Project:	EPS
Part Number:	80000258
Assembly Name:	LH7A404-11
Schematics	ECR

Title	LH7A404-11 Card Engine	Rev	201
Size	Custom	Number	80000258
Design Create Date	Friday, October 18, 2002	Project	LH7A404-11
		Sheet	2 Of 12

## 12 - ECO LIST

05 - FLASH

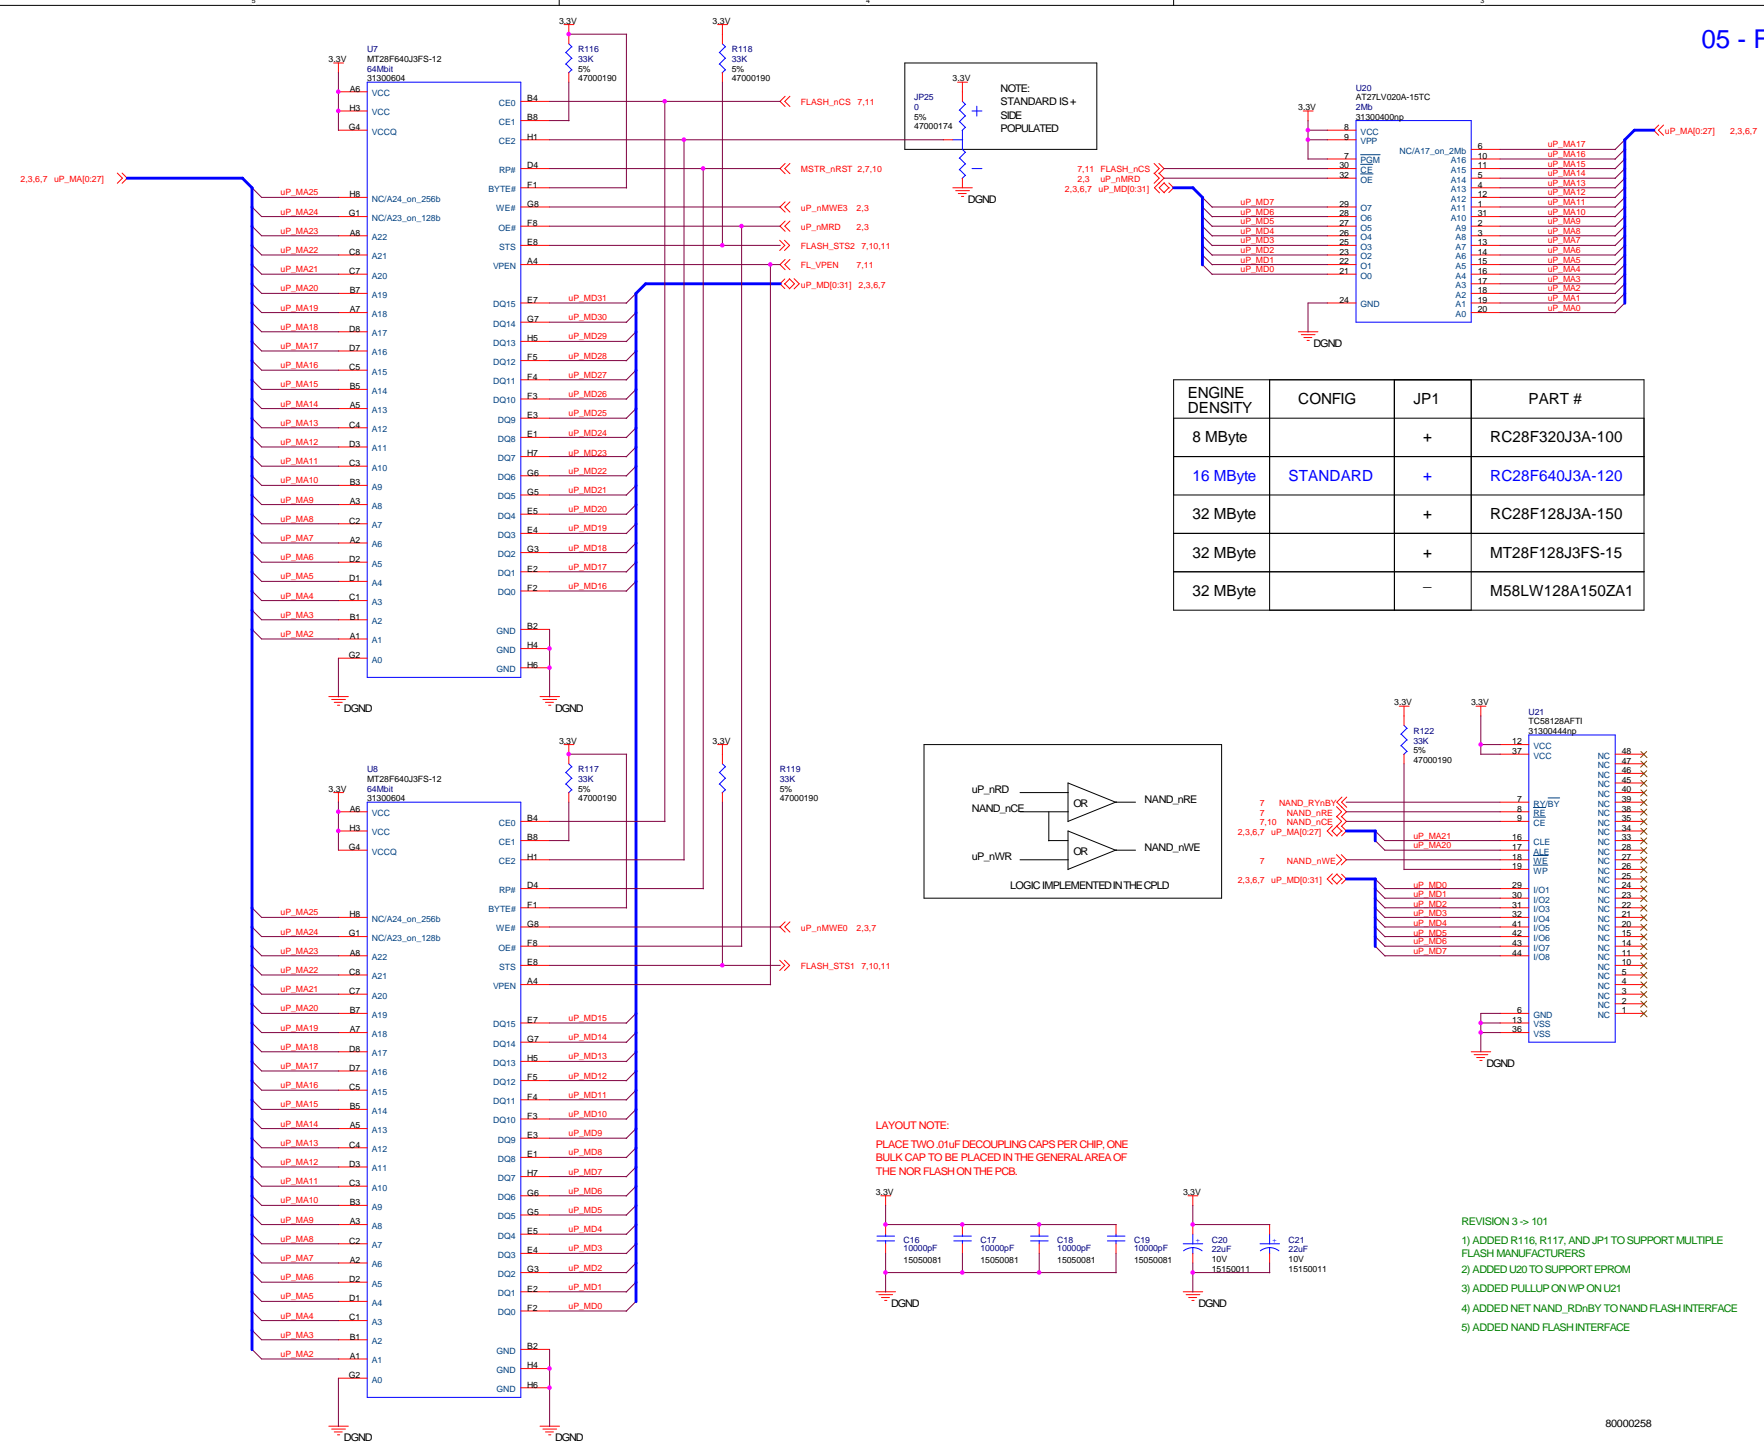
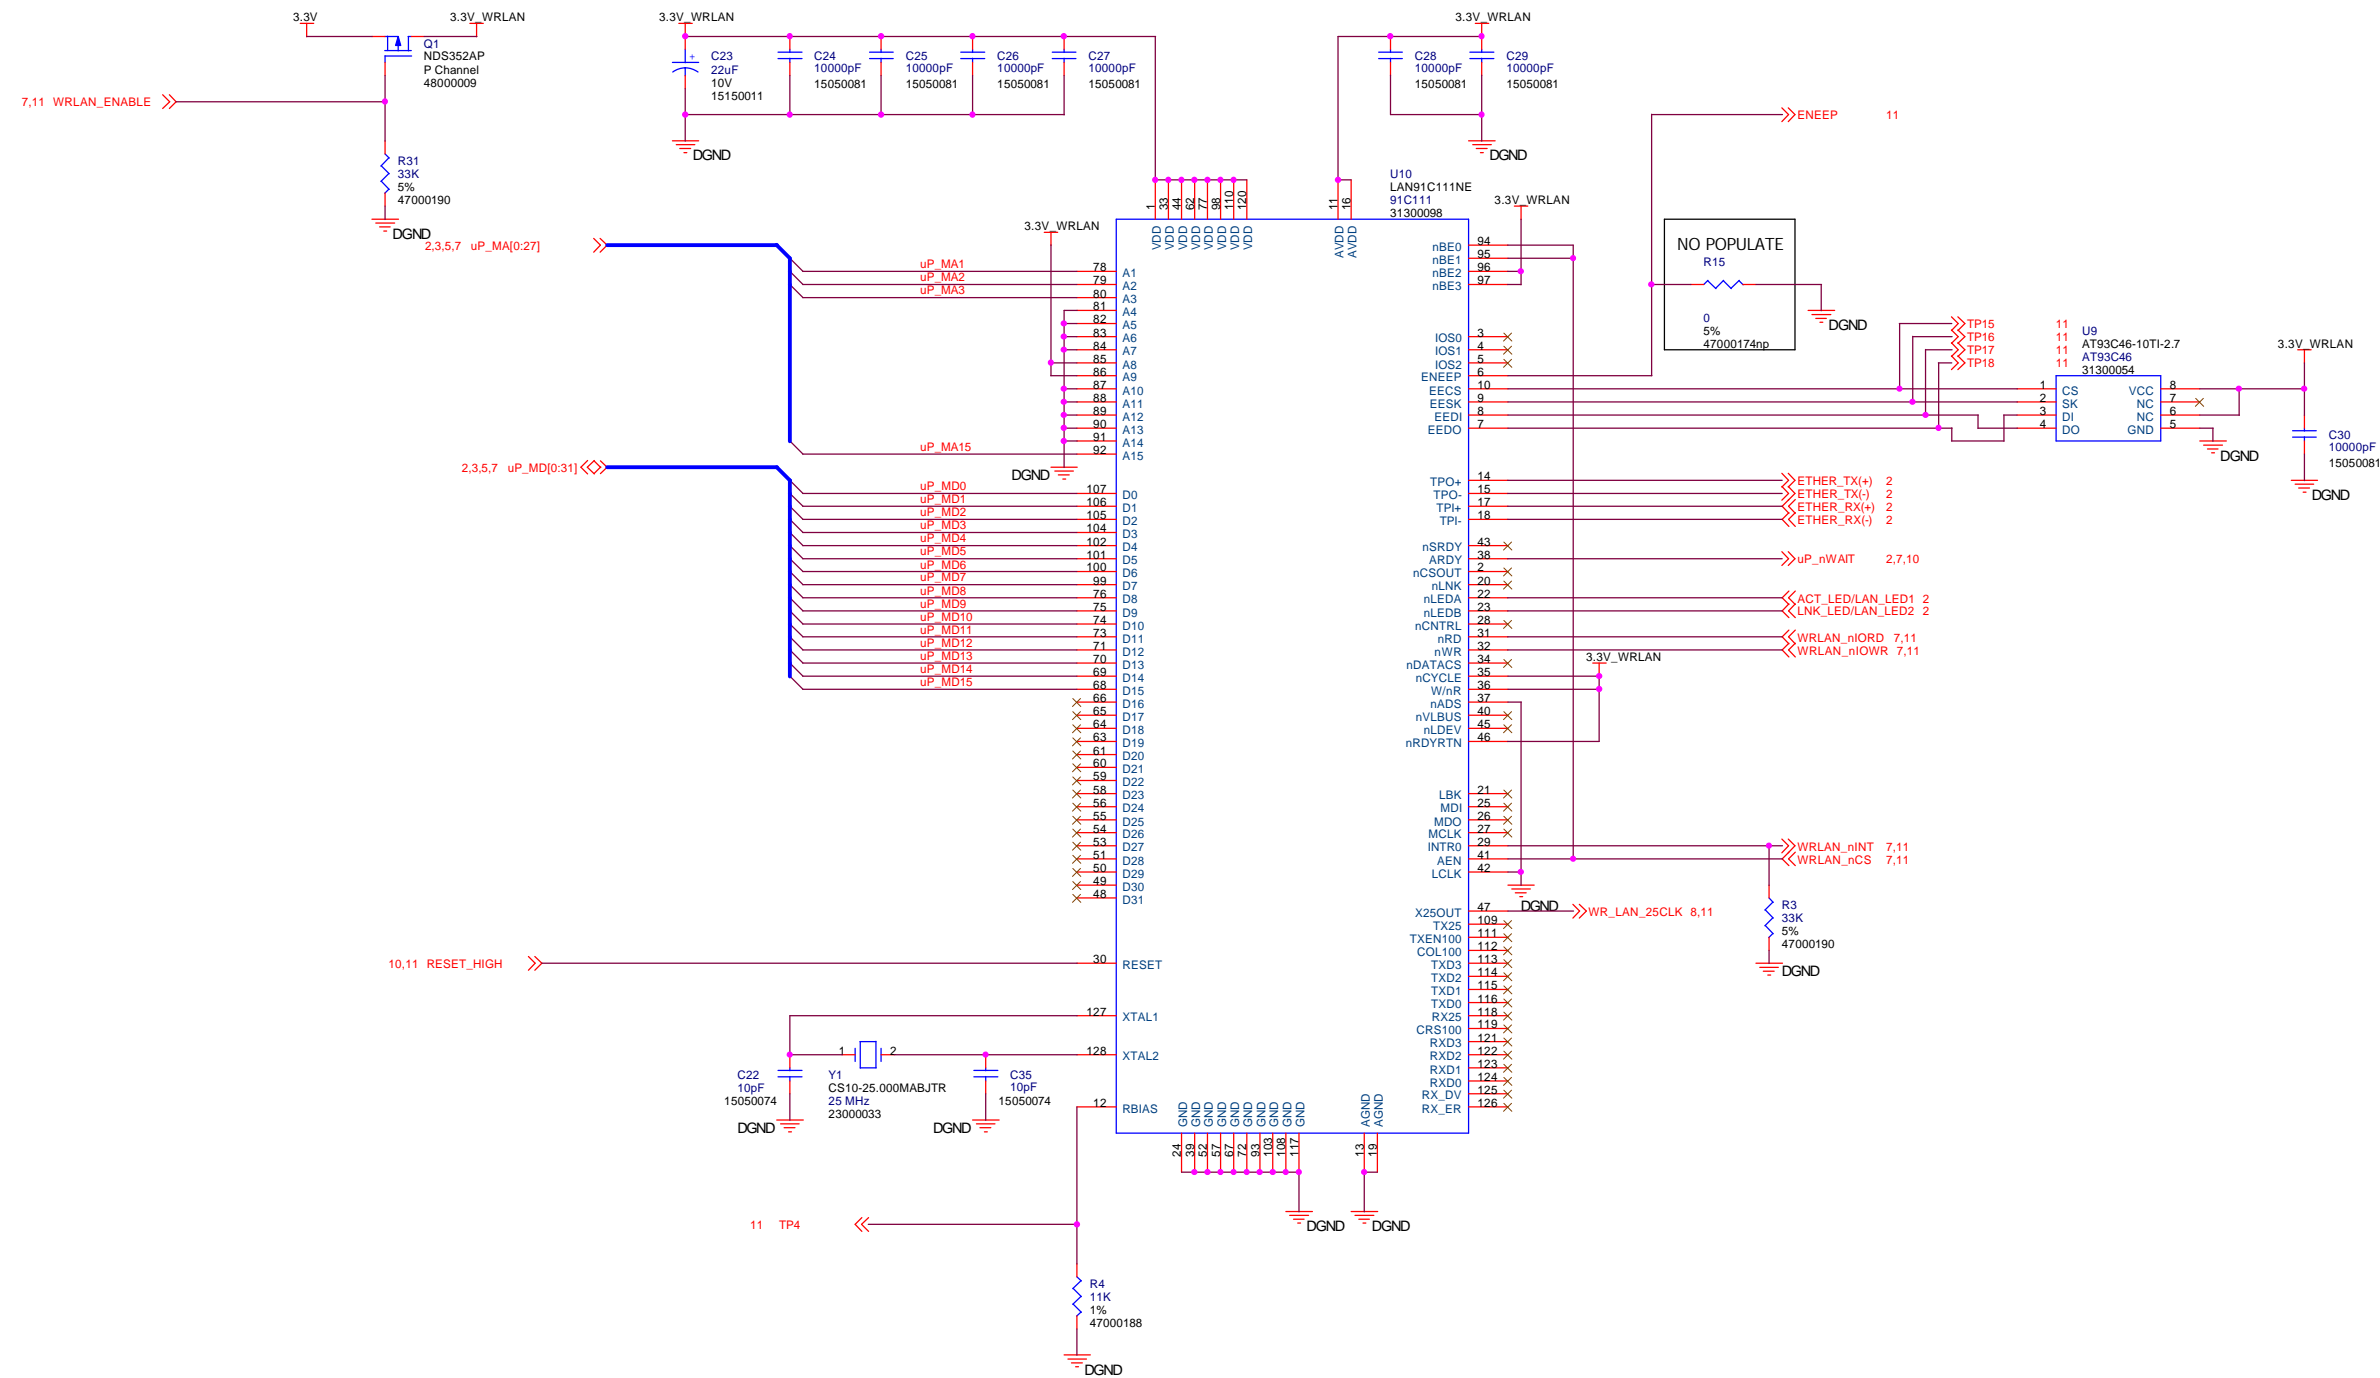
- REVISION 3 -> 101
- 1) ADDED R116, R117, AND JP1 TO SUPPORT MULTIPLE FLASH MANUFACTURERS
  - 2) ADDED U20 TO SUPPORT EPROM
  - 3) ADDED PULLUP ON WP ON U21
  - 4) ADDED NET NAND\_nRDnBY TO NAND FLASH INTERFACE
  - 5) ADDED NAND FLASH INTERFACE

1) CHANGED WR\_nWAIT TO uP\_nWAIT

<b>LOGIC</b> PRODUCT DEVELOPMENT		411 WASHINGTON AVE. N MINNEAPOLIS, MN 55401 PHONE: (612) 672-9495 FAX: (612) 672-9489
		Title LHTA404-11 Card Engine		
Size C	Number 80000258			Rev 201
Design Create Date = Friday, October 18, 2002		Project LHTA404-11	Sheet 8 Of 12

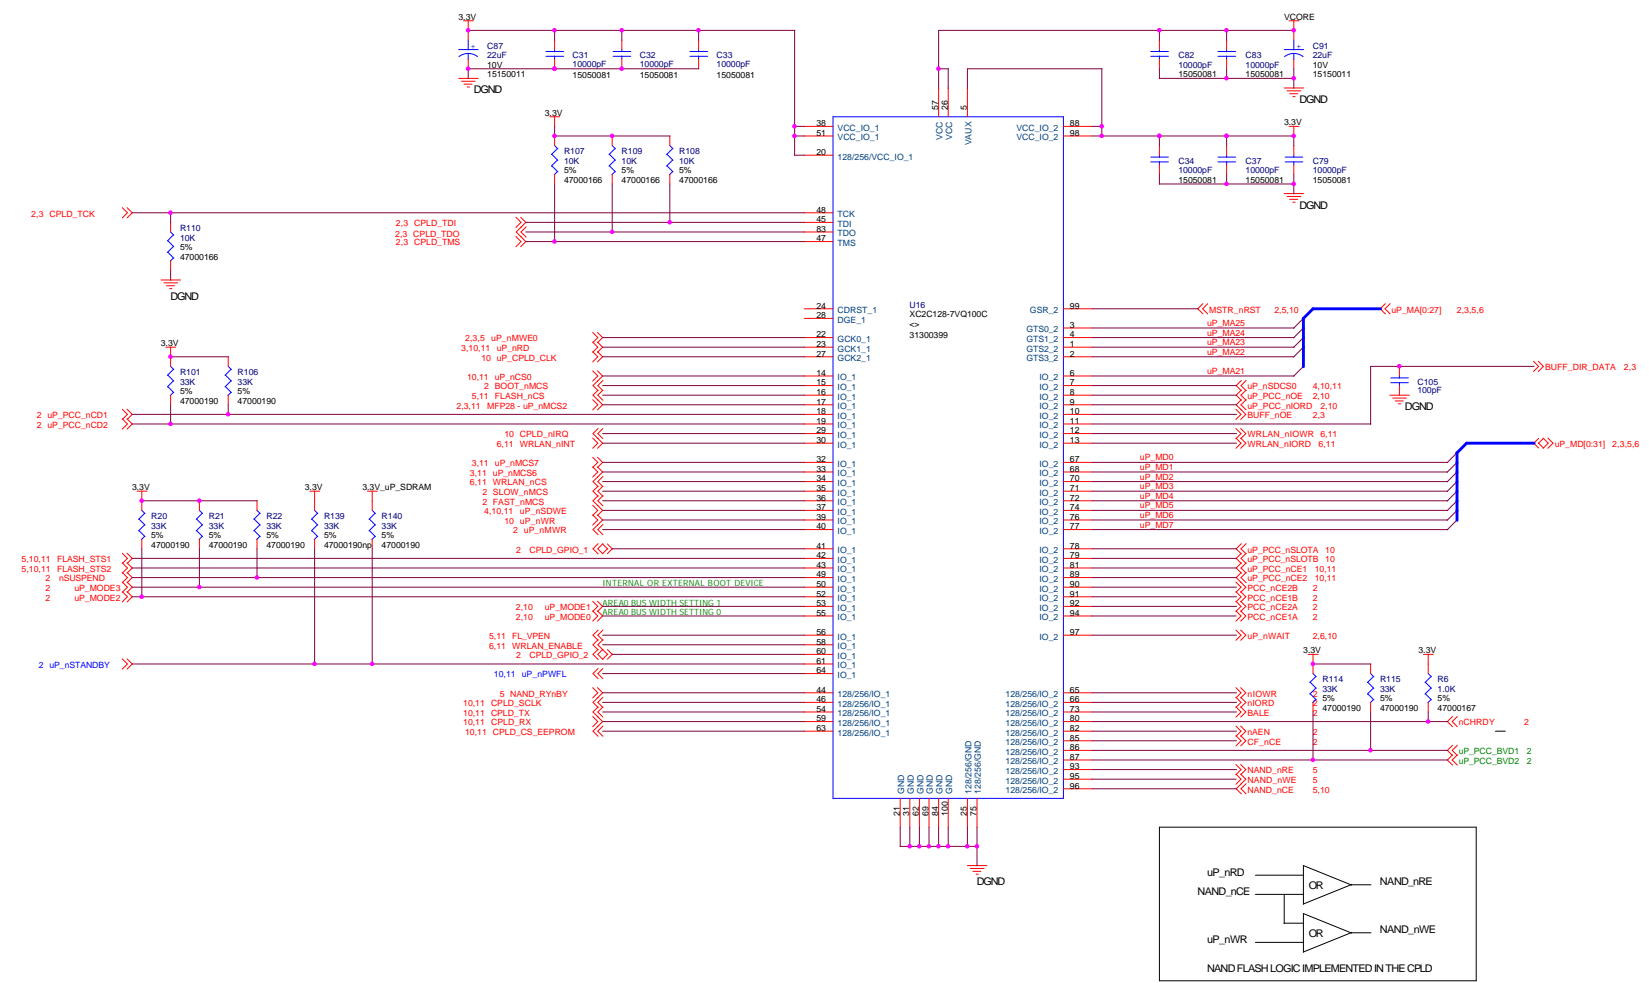
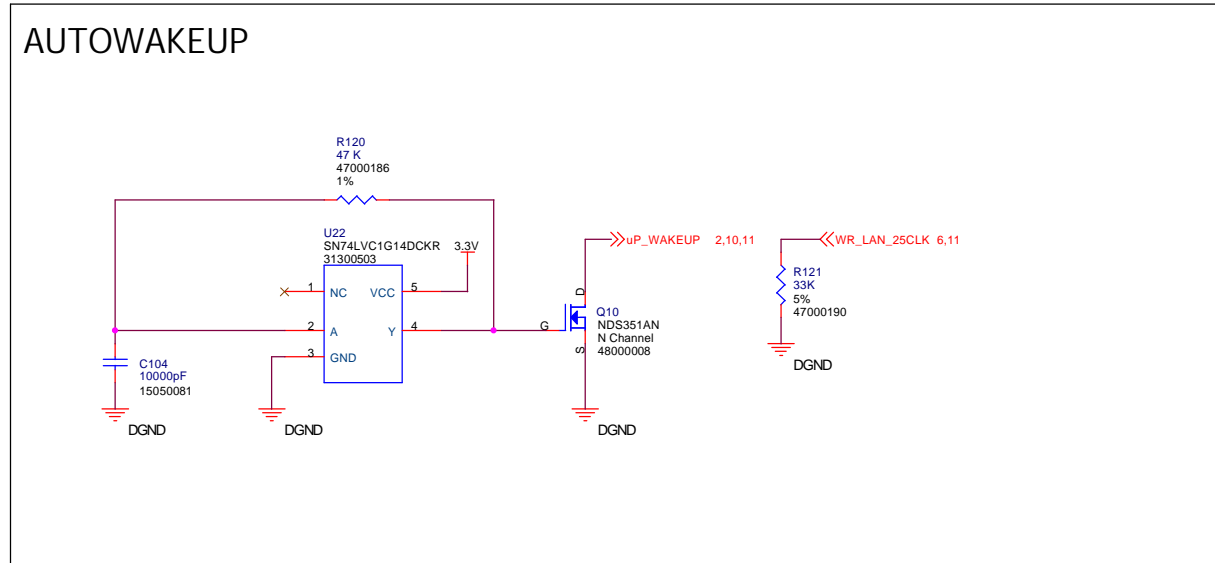
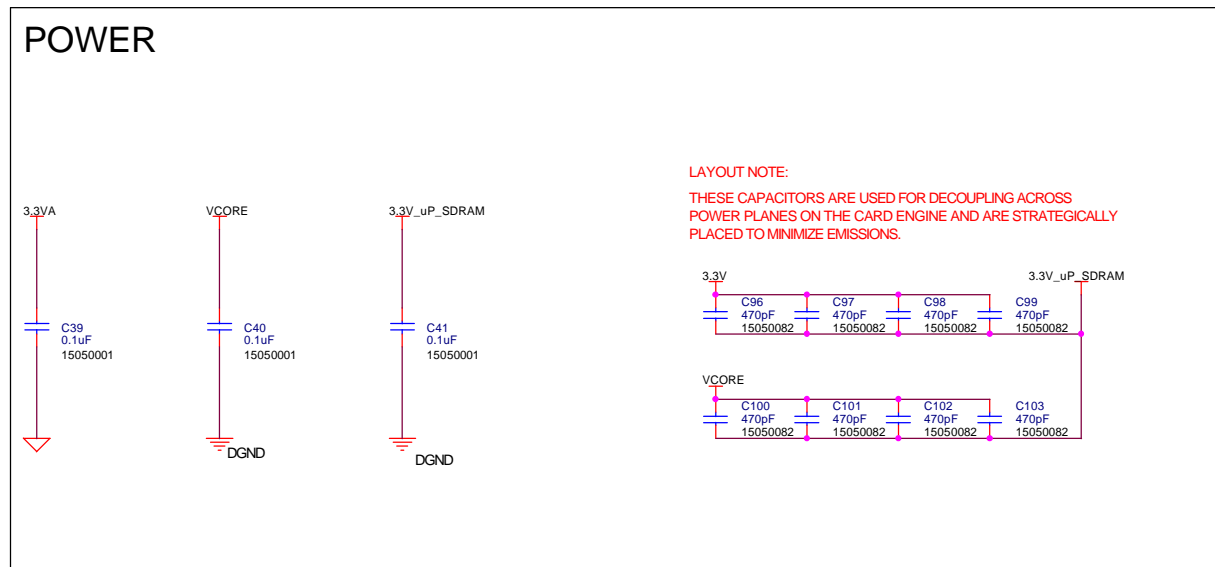
REVISION 101 -> 201  
 1) CHANGED NET NAME OF CPLD\_nCS\_EEPROM TO CPLD\_CS\_EEPROM BECAUSE IT IS ACTIVE HIGH  
 2) ADDED PULLUP TO NET uP\_nSTANDBY, THAT IS SELECTABLE BTWN 3.3V AND 3.3V\_UP\_SDRAM  
 3) FIXED CPLD JTAG LINES  
 4) ADDED CAP TO FILTER OUT POSSIBLE GLITCH ON BUFF DIR DATA NET

REVISION 3 -> 101  
 1) MOVED FROM ALTERA TO XILINX CPLD  
 2) REMOVED uP\_nWE3, BUFF\_DIR\_ADDRESS, uP\_AUX\_CLK\_INT, MFP30 - uP\_nSDCS2, MFP31 - uP\_nSDCS1 SIGNALS  
 3) REMOVED PULLUP ON BUFF\_nOE PIN  
 4) MOVED NETS uP\_PCC\_BVD1 AND uP\_PCC\_BVD2 TO THE FPGA AND R114 AND R115  
 5) ADDED NETS NAND\_nRE, NAND\_nWE AND NAND\_nCE TO THE FPGA  
 6) CHANGED NETS uP\_nCS6, uP\_nCS7, AND uP\_nCS2 TO BE BUFFERED INPUTS TO THE CPLD NAMED uP\_nMCS6, uP\_nMCS7, AND MFP28 - uP\_nMCS2  
 7) ADDED NET NAND\_nRDnBY FOR NAND FLASH INTERFACE  
 8) ADDED PULLDOWN TO USB OVERCURRENT SIGNAL  
 9) REMOVED NETS WRLAN\_25, AND uP\_WAKEUP, AND ADDED uP\_STANDBY AND NEW NET uP\_nPWFL

REVISION 2 -> 3  
 1) MOVED uP\_PCC\_nCD1 AND uP\_PCC\_nCD2 FROM PROCESSOR TO CPLD  
 2) MOVED CPLD\_nCS\_EEPROM TO NEW PIN ON CPLD  
 3) REMOVED uP\_nROE, RENAMED uP\_nROD TO CPLD\_nIRO  
 4) ADDED INPUT uP\_nWR AND uP\_nSDWE TO CREATE uP\_nMWR  
 5) CHANGED uP\_nMWR TO AN OUTPUT  
 6) REMOVED RSVD\_1, MFP29 - CPLD\_GPIO\_3  
 7) REMOVED R9  
 8) ADDED R107, R108, R109, R110  
 REVISION 1 -> 2  
 1) ADDED R105 PULLUP TO uP\_WAKEUP  
 2) RENAMED CHIP SELECTS AND MADE uP\_nCS6 AND uP\_nCS7 AS INPUT TO CPLD AND CPLD NOW CREATES FAST\_nMCS AND SLOW\_nMCS  
 3) REMOVED uP\_PCC\_nCE1, uP\_PCC\_nCE2 FROM THE CPLD, WR\_nWAIT, AND EXTRA uP\_nRD SIGNAL  
 4) ADDED uP\_nMWR, uP\_PCC\_nROD, AND uP\_PCC\_nOE TO CPLD  
 5) CHANGED PULL UP R6 TO 1K OHM  
 6) ADDED PC CARD CE1, CE2, SLOT1, AND SLOT2 SIGNALS TO CREATE SEPERATE CE SIGNALS FOR DUAL PC CARDS A AND B

<b>LOGIC</b> PRODUCT DEVELOPMENT		411 WASHINGTON AVE. N MINNEAPOLIS, MN 55401 PHONE: (612) 672-9495 FAX: (612) 672-9489
		Title LHTA404-11 Card Engine		
Size C	Number 80000258			Rev 201
Design Create Date = Friday, October 18, 2002		Project LHTA404-11	Sheet 9 Of 12

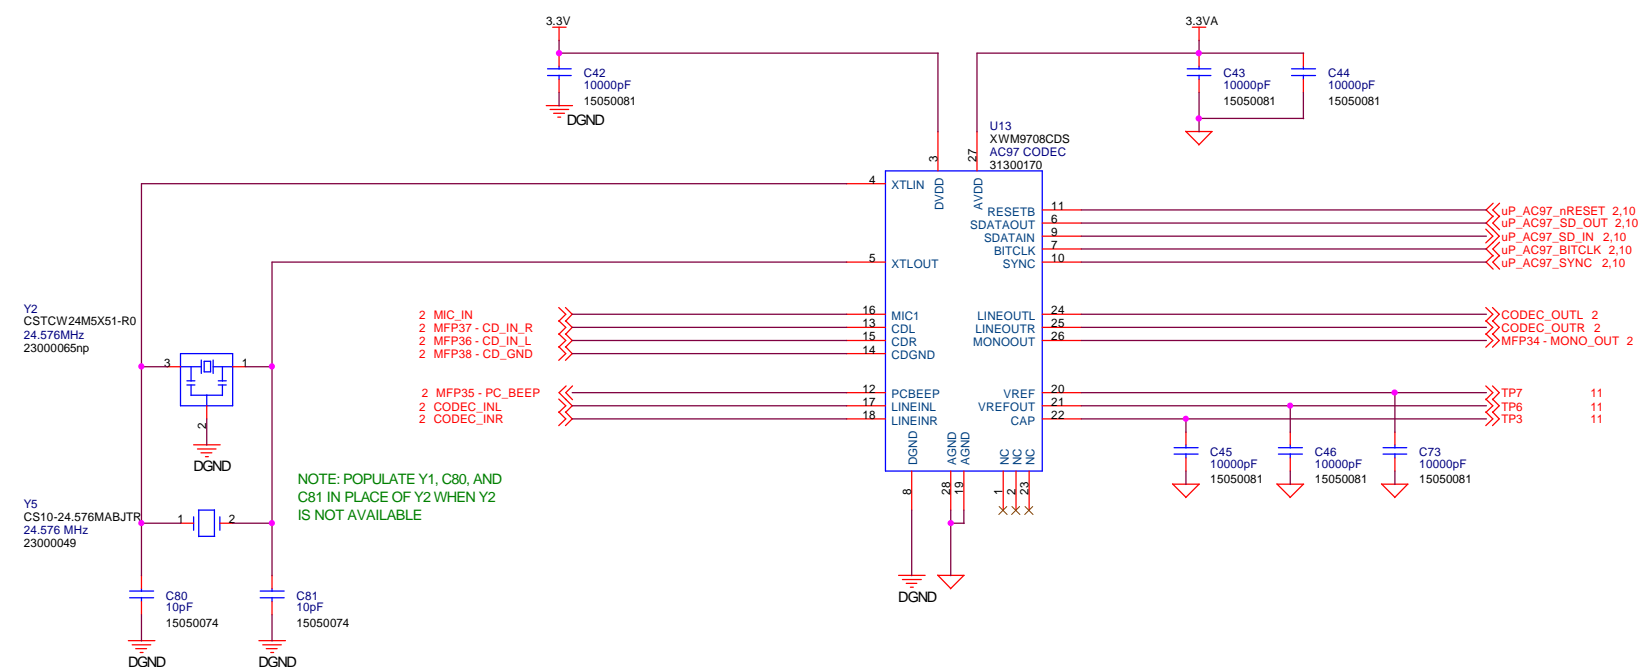
REVISION 1 -> 2  
 1) ADDED Y5, C80, C81 FOR AN ALTERNATE TO RESONATOR  
 2) SWAPPED uP\_AC97\_SD\_OUT AND uP\_AC97\_SD\_IN SIGNALS ON WOLFSON CODEC
